Development Application **ACCESS REPORT**

Reference Number: 24232

110-112 Deccan Street, Goulburn NSW

Executive Summary and Design Compliance Statement

[Image description: Plan of Basement level above shows the provision of Accessible parking spaces]

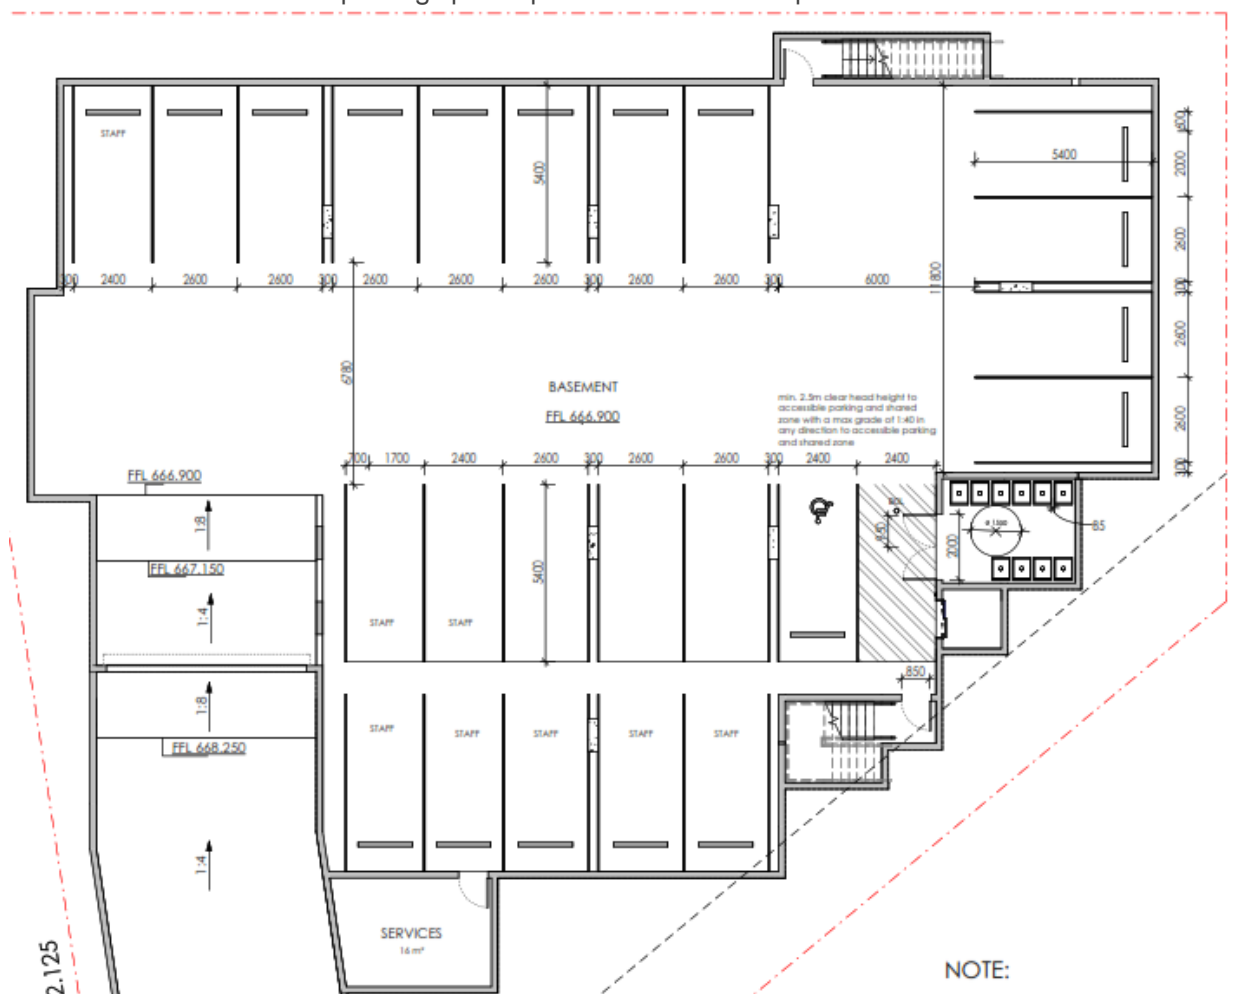
Total number of Accessible parking spaces required in the development = 1

Total number of Accessible parking spaces provided in the development = 1
